This document informs you about the new encoder-line OCD II CANopen, that replaces the older OCD CAN series since the beginning of 2010. As you perhaps recognized, the received encoder has a different type key and is shorter than before.

Technical information 1 Enhanced Functionality

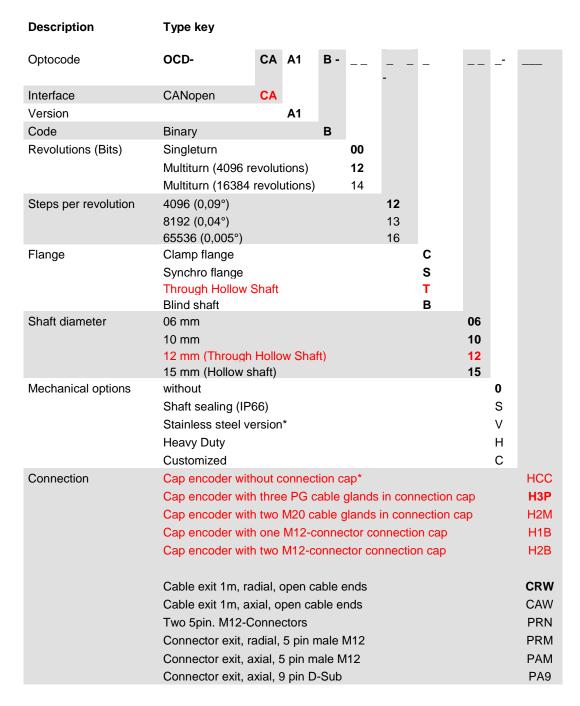
The application of a reducing adapter allows the reduction of the diameter of a blind hollow shaft encoder. It is reducible down to 6mm and is currently handled as 'Set Encoder + Reducing Adapter'. Until now, this was handled as "Set Encoder + Reducing Adapter".

In future the reduced inner diameter will become an integral part of the encoder type key:

0149000039 Set encoder + Reducing adapter (Full type key is 'Set OCD-C5B1B-1213-B150-PA9+ Reducing adapter RR12')

OCD-CAA1B-1213-B120-PA9
